## Comparison of RODs and Current amendment application – to be included in the 2020 amendment application

Note that amendments have been highlighted (example) and, where text has been removed, it is absent from the proposed amendment.

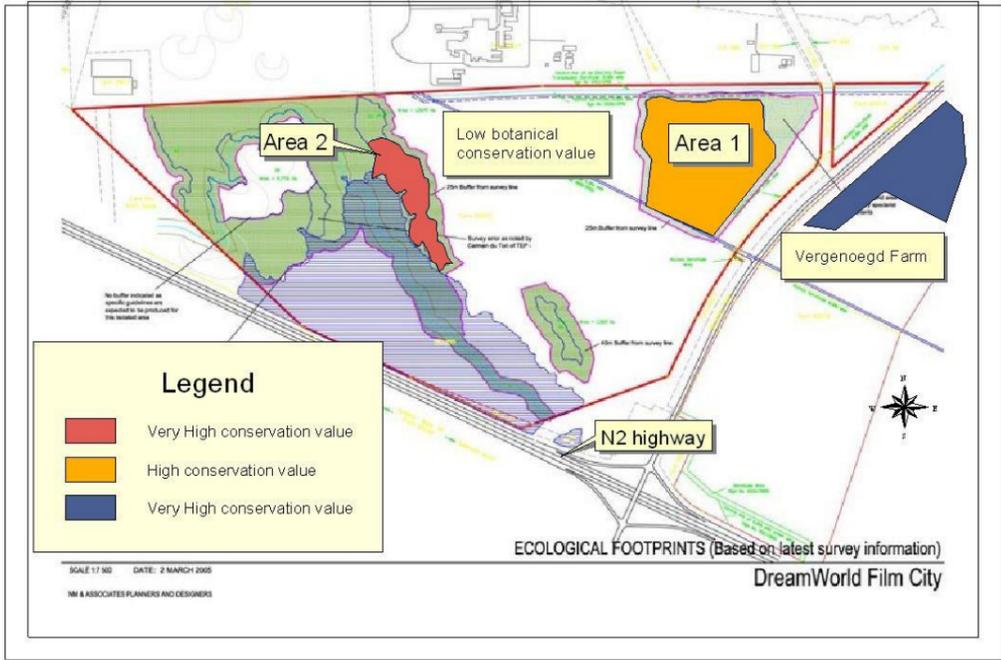
2	<p>Residential land use on south-western and eastern portion (37 ha) including</p> <ul style="list-style-type: none"> <li>14.43 ha area along southern border (adjacent to N2)</li> <li>11.6 ha residential in central portion</li> <li>2,86ha residential area along R310</li> <li>3.3 ha residential on portion 14 (triangle along R310)</li> <li>5ha Residential along northern boundary.</li> </ul>	<p>Residential land use on south-western and eastern portion (37 ha) is amended including</p> <ul style="list-style-type: none"> <li>14.43 ha residential area along southern border (adjacent to N2) reduced to 11.25 ha with straightened boundaries.</li> <li>11.25 ha residential in central portion remains</li> <li>2,86ha residential area along R310 is converted and integrated into the (mixed use) development area (9.46 ha)</li> </ul>	<ul style="list-style-type: none"> <li>The 12 ha residential land area south of the main access road would be amended to mixed use and is labelled as Mixed Use 1 in the proposed amended DF in <b>Appendix E (ii)</b>. Note that Mixed Use Area 1 would also comprise the mixed use area south of the primary access road currently approved.</li> <li>The 11.25 ha residential in central portion (labelled as Residential Area 1 in the proposed amended DF in <b>Appendix E (ii)</b> and Residential Area 3 in <b>Appendix E (i)</b>) would remain as is, with the inclusion of an indigenous landscaped buffer with the main green corridor.</li> <li>The 2.29 ha residential area (Residential Area 1b in the current approved DF in <b>Appendix E (i)</b>) (triangle along R310) would be enlarged to 2.59ha and amended to mixed use (refer to Mixed Use Area 3 in <b>Appendix E (ii)</b>). The maximum allowable building height (of approximately 8m) would be retained. The visual impacts of the change of use from residential to mixed use has been assessed and found to be appropriate (refer to <b>Appendix G (iii)</b> for the full visual assessment).</li> <li>The 9.46 ha residential area (i.e. "revised development area") north of the primary access road in the current approved DF would be amended to mixed use (labelled as Mixed Use 2 in the proposed amended DF) and the boundaries reconfigured in order to accommodate additional access roads. This revision of boundaries would affect the Renosterveld Area boundaries, but not the total extent</li> </ul>

<ul style="list-style-type: none"> <li>• 3.3 ha residential on portion 14 (triangle along R310) remains but is reduced to 2.29 ha to accommodate the green corridor along the R310.</li> <li>• The northern part of the 5ha residential along northern boundary is removed (cut diagonally) to allow for the conservation of the highly sensitive Renosterveld area. This area was swapped for a portion of Renosterveld wetland area (of lower conservation value) along the southern access road.</li> </ul>	<p>thereof as additional Renosterveld Area along the canal would be demarcated (refer below to number A4 in this table for more detail on the reconfiguration thereof into the Renosterveld Area). The realignment of the northern access road (i.e. moving further west, down the primary access road) occurs in this area, and includes two turning circles. The encroachment into the Renosterveld Area has been considered by a botanist and found to have a slightly higher impact, Medium (-), (without mitigation) than the current approved DF in this area, Low (-), but that there is no particular preference for either the current approved or the proposed amended DF (refer to <b>Appendix G (i)</b> for the full report). The botanical impact of this encroachment remains lower than that of the overall botanical impact of the DF identified in the initial S&amp;EIA.</p> <ul style="list-style-type: none"> <li>• The building height of buildings along the R310 in the mixed use areas would be limited to 8m.</li> <li>• The visual impacts of the change in land use from residential to mixed use for mixed use areas 1, 2, and 3 have been assessed by a specialist as those areas are located along the R310 (a scenic route). The impacts were found to be similar or less than those identified in the S&amp;EIA and contained in the RoD, and are therefore considered acceptable, provided that the height limit of two storeys along that edge is adhered to. Key mitigation measures with regard to building height limits for buildings along the R310 as well as landscaping have been adopted as part of the proposed amended DF and associated landscaping plan. The full visual assessment report can be found in <b>Appendix G (iii)</b>.</li> </ul>
